ADDENDUM NO. 1

To the Contract Documents for
Borough of Mount Arlington
Windemere. Altenbrand, and Park Water Main Extension
dated May 2020

FIGURE 500-14A		
MORRIS COUNTY TYPICAL DETAIL HMA PAVEMENT DETAIL		
NOT TO SCALE	9/2011	MOC

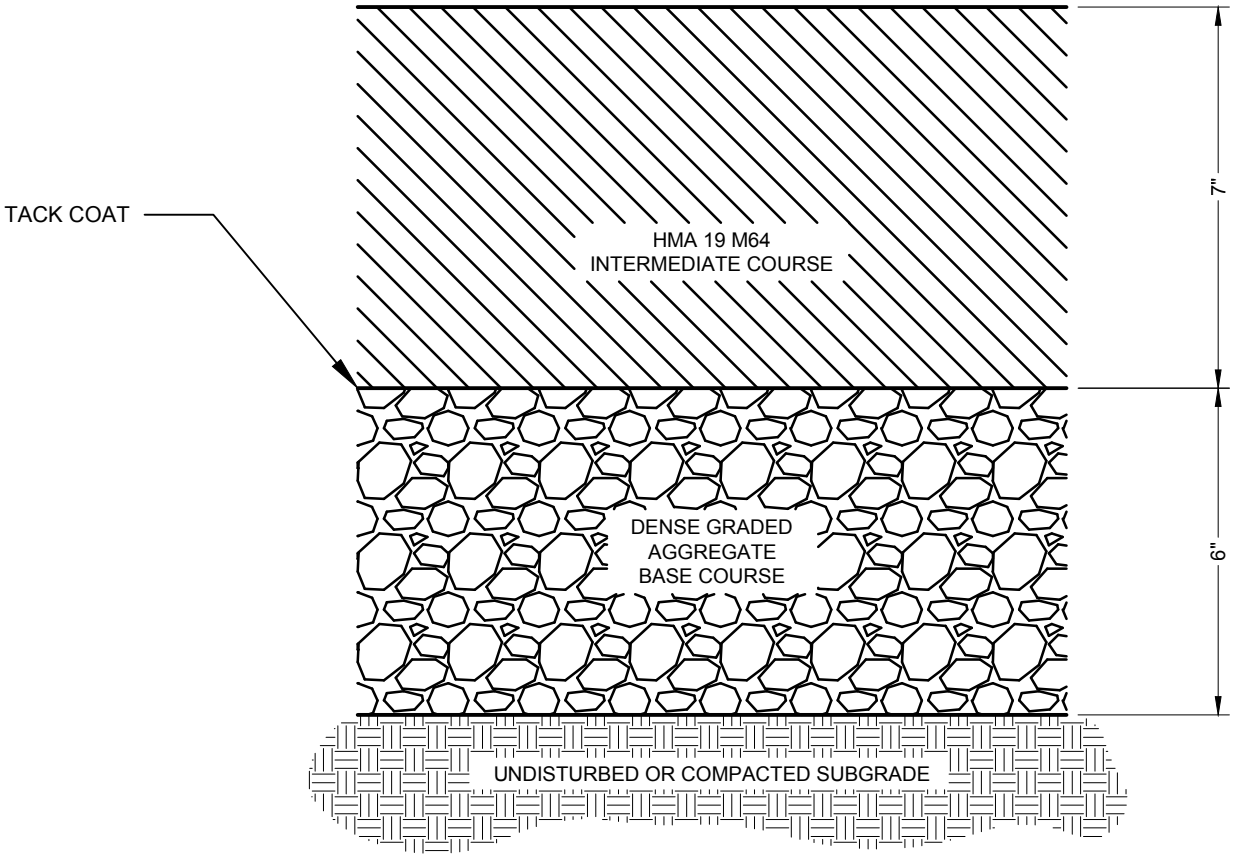
On drawing Sheet 06, replace "Typical County Pavement Detail" with Morris County Figure 500-14A (attached)

FIGURE 500-15A		
MORRIS COUNTY TYPICAL DETAIL TRENCH DETAIL		
NOT TO SCALE	5/2011	MOC

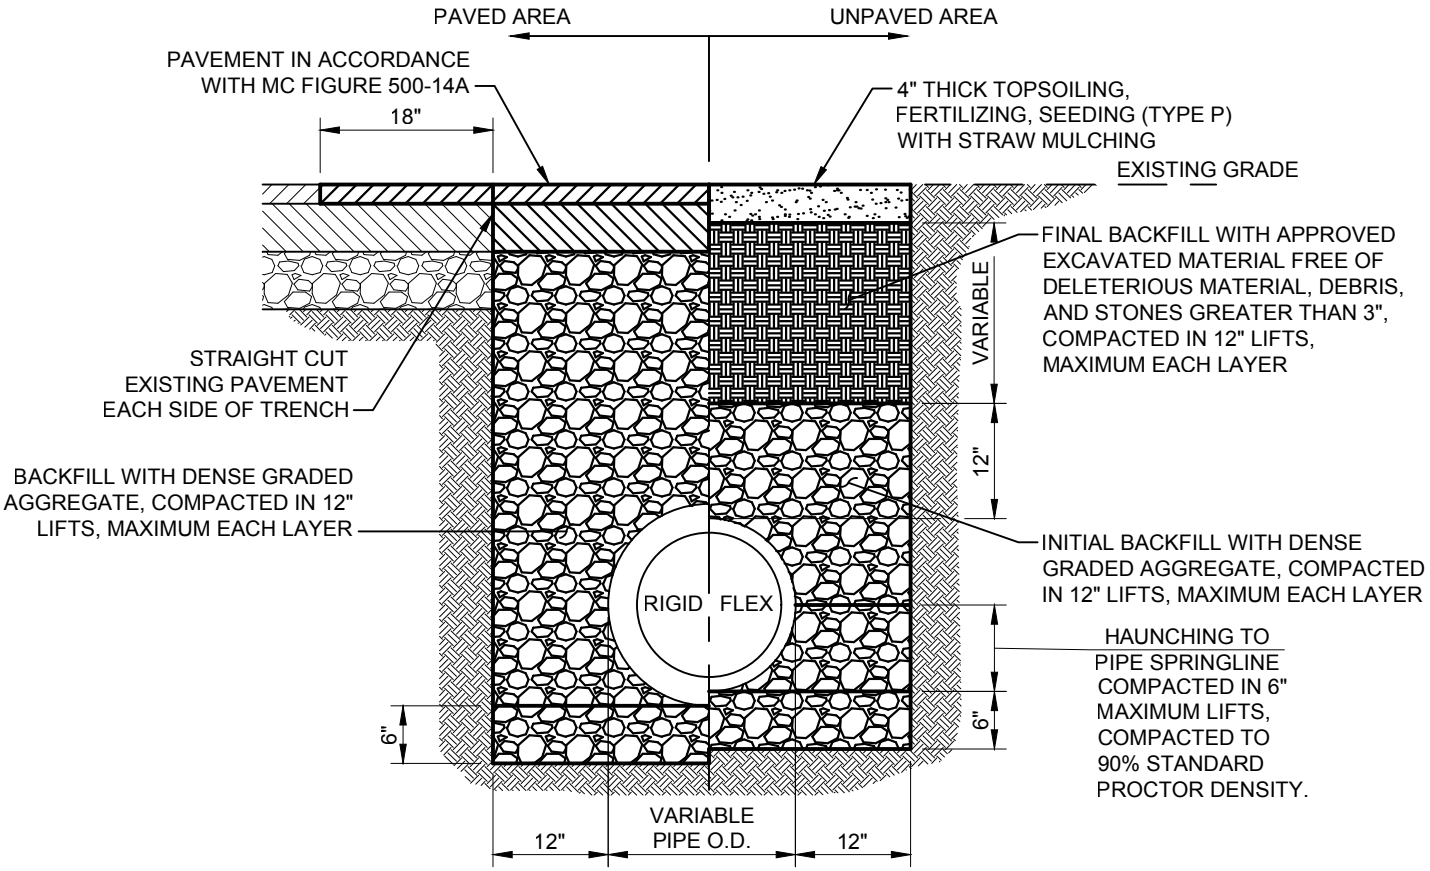
On drawing Sheet 07, insert Morris County Figure 500-15A with title "County Trench Detail" (attached)

FIGURE 500-08		
MORRIS COUNTY TYPICAL DETAIL GRANITE BLOCK CURB		
NOT TO SCALE	12/2019	WMW

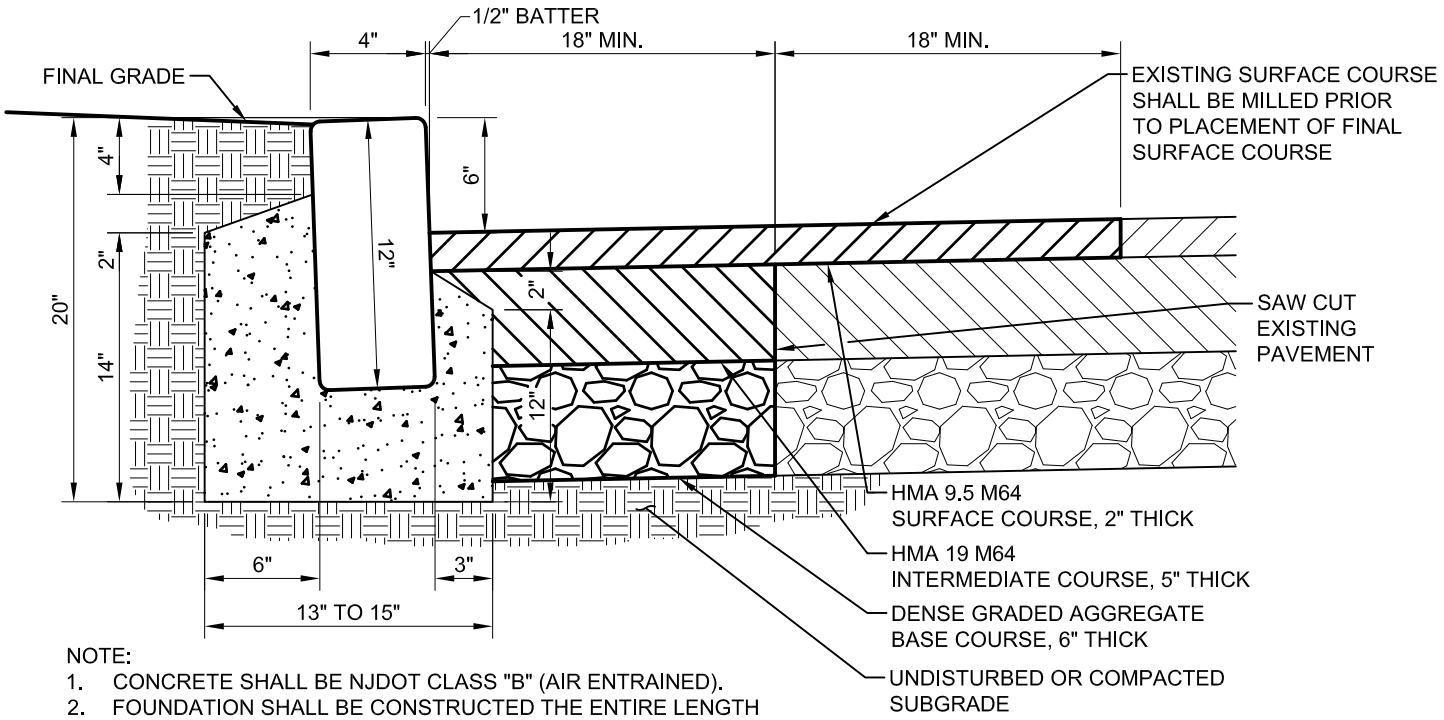
On drawing Sheet 06, insert Morris County Figure 500-08 with the title "County Granite Block Curb Detail" and Figure 500-09 with the title "County Granite Block Depressed Curb Detail" (attached)
